UNITED STATES PATENT AND TRADEMARK OFFICE

APPLICATION NO.	FILING DATE	FIRST NAMED INVENTOR	ATTORNEY DOCKET NO.	CONFIRMATION NO.
10/511,485	10/15/2004	Seiichi Uemoto	F-8423	4404
28107 7590 04/13/2007 JORDAN AND HAMBURG LLP 122 EAST 42ND STREET SUITE 4000 NEW YORK, NY 10168			EXAMINER CANTELMO, GREGG	
			ART UNIT	PAPER NUMBER
			1745	
SHORTENED STATUTORY PERIOD OF RESPONSE		MAIL DATE	DELIVERY MODE	
3 MONTHS		04/13/2007	PAPER

Office Action Summary	Application No. 10/511,485	Applicant(s) UEMOTO ET AL.	
	Examiner Gregg Cantelmo	Art Unit 1745

DETAILED ACTION

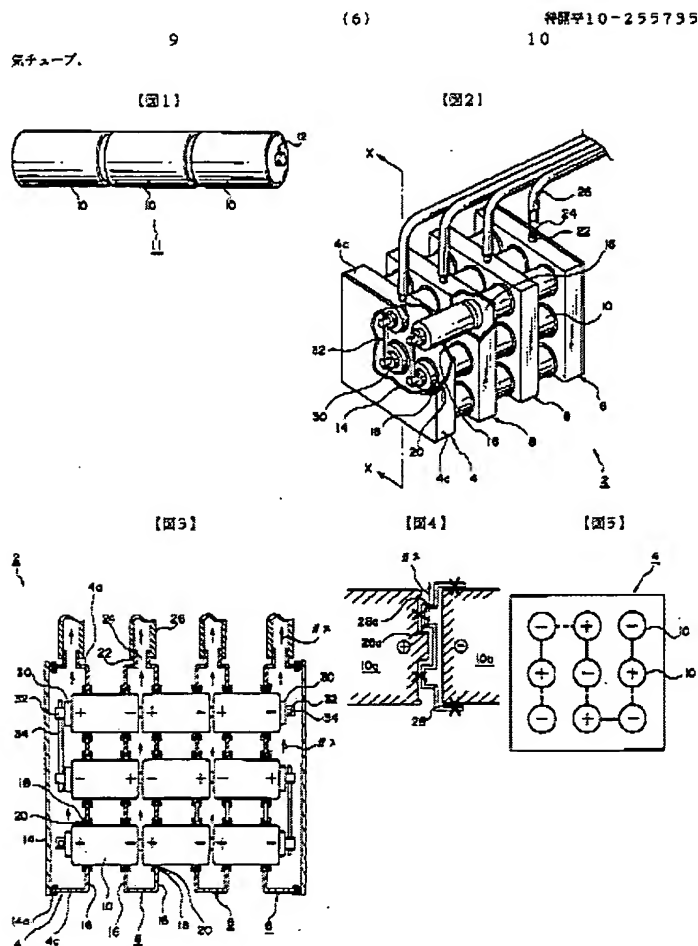
Bedell discloses a battery pack, including a plurality of batteries 5 arranged in parallel and accommodated in a case 2 that forms a cooling-air passage, wherein the cooling-air passage (bottom section below separating plate 4) and a gas-discharge passage (upper section above separating plate 4) for discharging gas leaking from the batteries when the batteries fall into abnormal state are formed and separated from each other in the case by plate separator 4 (Fig. 2 as applied to claim 1).

As to the recitation of the batteries falling into an abnormal state: while intended use recitations and other types of functional language cannot be entirely disregarded. However, in apparatus, article, and composition claims, intended use must result in a structural difference between the claimed invention and the prior art in order to patentably distinguish the claimed invention from the prior art.
